# AMC2

## Controllers and extension boards

### Misalignment of laser marking on certain connectors

Figure 1.1: 7-pin connector

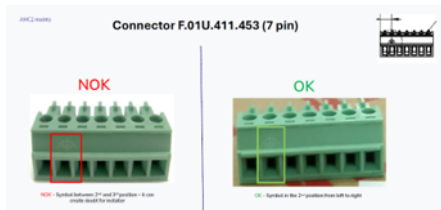
Certain connectors of the AMC2 show unclear, misaligned indications for the earth ground symbol . Root cause was an intermittent misadjustment of the laser marking machine.

Typically, affected connectors show an unclear position of the earth ground symbol .

1. Modifications to the machine adjustment have been implemented.
2. Inventories at the factory and in the regional warehouses were blocked and re-worked accordingly.

- If you have installed the AMC2 product and it runs as expected, you do not need to do rewiring.
- If you face issues during the initial installation, please check the pin position of the connectors according to the installation manual and do rewiring.
